GROUP	MODEL
ELE	2023MY Sportage (NQ5a)
NUMBER	DATE
256 (Rev 1, 06/03/2022)	May 2022

## TECHNICAL SERVICE BULLETIN

SUBJECT: **SERVICE ACTION: TRANSMISSION WIRE HARNESS UPGRADE AND RELATED DTC P07XX, P0880 (SA499)**

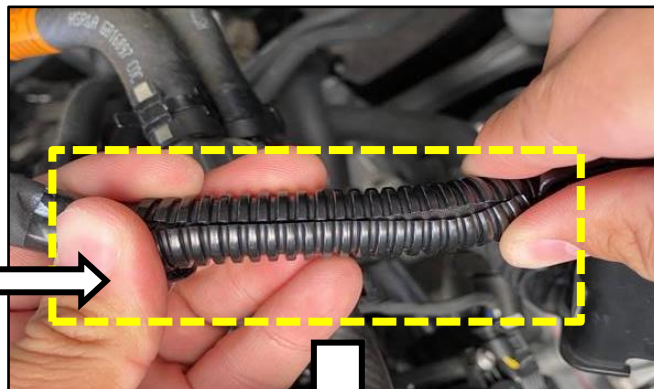
4. Locate the repair area shown between the harness clip (C) and zip tie (F).

If damage to the wire insulation is found, wrap the affected wire(s) with electrical tape prior to continuing with the repair procedure below.

5. Cut a piece of the plastic conduit flex tubing to 90mm (3.5" inch) in length.

**Note:** Use high temp (275° F) ½" inch (13mm) plastic conduit flex tubing.

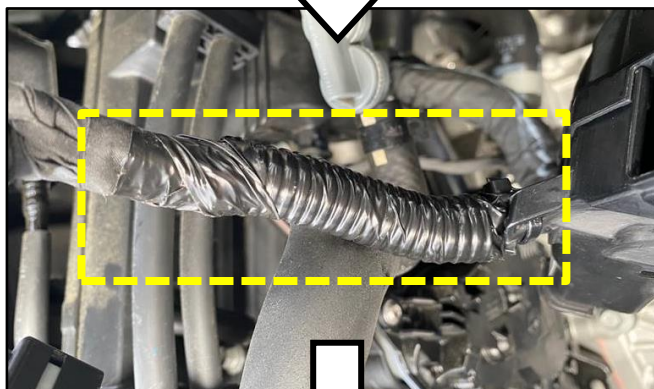
6. Cover/wrap the repair area of the control harness using the plastic conduit tubing as shown.

7. Adhere high-temperature 3M™ electrical tape around the entire length of the plastic conduit tubing as shown.
8. Reinstall all removed parts in the reverse order of removal.

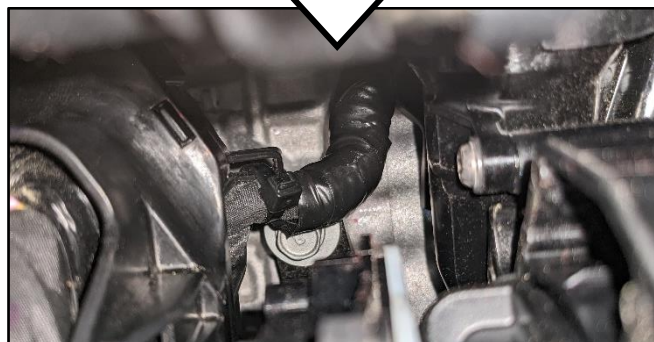
9. Confirm that the control harness is not in contact with the shift cable bracket bolt and normal operation of the vehicle.
